K157. A ROLLING CODE 2-CHANNEL UHF REMOTE CONTROL

TRACK ERROR. Now I made a **track error** when making these PCBs which, strangely, the prototype did not pick up. It is only when you try to add more than one TX units to the RX that the error shows up and does not allow you to do so. I do try to make error-free PCB's but …. I have connected each track to the tact switch to itself inside the tact switch. That is, pin 7 of the RX module is shorted to ground permanently inside the tact switch. I mis-identified which pair of legs were internally connected together; an embarrassing mistake.

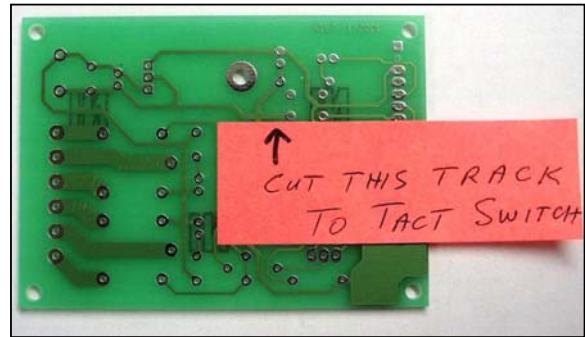
As mentioned there is a track to cut and link to make. Cut the track going to the zippy switch as indicated in the photo.

Connect the other side of the tact switch to ground as shown. Use an offcut fron resistor leg. See it at
http://www.kitsrus.com/jpg/k157jump.jpg

You can see the cut track.

Please cut one track as shown in the photo below and then jumper a leg from the tact switch 0.2" / 5mm to a pad next to it as shown in the photo. Then all is OK. Use an offcut from a resistor leg. This modification should not cause you any problem once you understand the error and look at the photos.

Then use an offcut from a resistor leg to jumper across two pads as shown in the other photo. Now when the tact switch is pressed pin 7 of the RX module will go to ground and **LEARN**ing of additional TX units will occur.
